Subject: UniStar Nuclear Energy, NRC Docket No. 52-016  
Response to Request for Additional Information for the  
Calvert Cliffs Nuclear Power Plant, Unit 3,  
RAI 316, Seismic System Analysis

**Response to NRC Request for Additional Information  
RAI No. 316, Question 03.07.02-67, Seismic System Analysis  
Calvert Cliffs Nuclear Power Plant, Unit 3**

**Question 03.07.02-67**

Figure 1: Quarter Model of the CBIS at CCNPP3

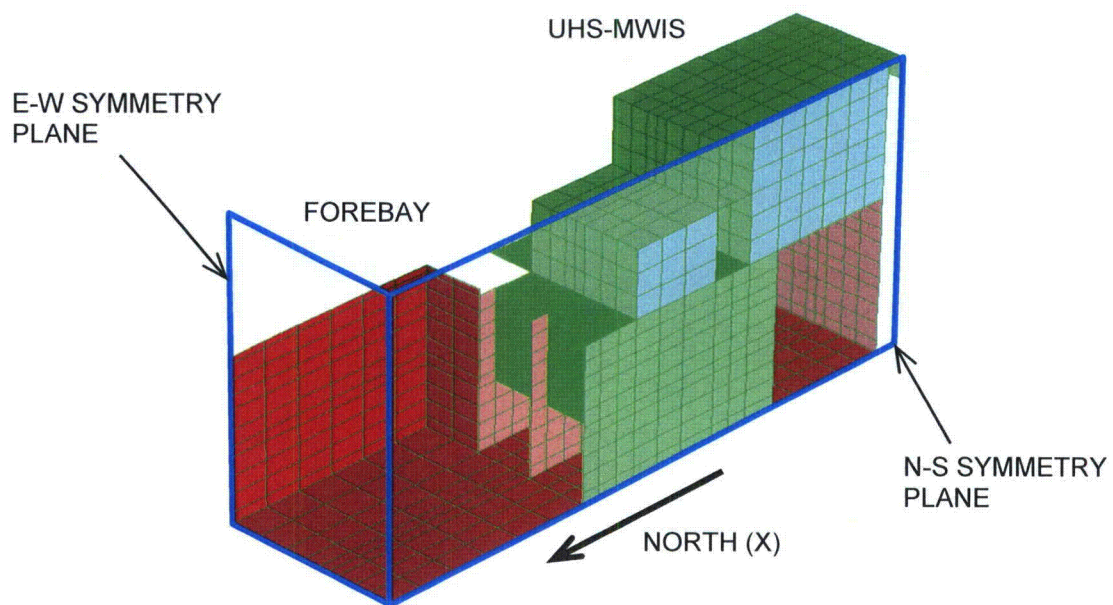
The Defense Nuclear Facilities Safety Board (DNFSB) issued a letter on April 8<sup>th</sup>, 2011 requesting that the Department of Energy (DOE) address technical and software quality assurance issues related to potentially erroneous seismic analyses performed using the SASSI subtraction method. Versions of SASSI are used by CCNPP3 in the seismic analyses of the ESWB (Bechtel Computer Code SASSI 2000, Version 3.1) and the CBIS (RIZZO Computer Code SASSI Version 1.3a) both of which are modeled as embedded structures. Therefore, the subtraction issue may be of concern in the analyses of these structures if it was used in the SASSI modeling approach. It may also be a concern in any future analysis of the NI where embedment effects are considered.

- a. Identify whether the SASSI Subtraction method is used in the seismic analyses
- b. Describe how CCNPP3 addresses the technical and software quality assurance issues raised by DNFSB letter in the versions of SASSI which CCNPP3 uses for seismic analyses
- c. If the SASSI Subtraction method is used by CCNPP3, provide an assessment to establish: 1) the seismic analyses performed in support of the CCNPP3 COL application do not contain any errors or anomalies as identified in DNFSB letter, 2) QA steps taken to ensure any future seismic analyses in support of the CCNPP3 COL application will be free from errors or anomalies as identified in DNFSB letter

A quarter model of the CBIS is created by adding two symmetric planes along the X (NS) and Y (E-W) directions (Figure 1). The results of this analysis are compared with the same structure analyzed with the Subtraction Method at several locations. The "interaction nodes" considered in the Flexible Volume Method or "direct method" model are all nodes belonging to the excavated soil volume. On the other hand, the interaction nodes considered in the Substructure Subtraction Method model are those located at the outer perimeter boundary of the excavated
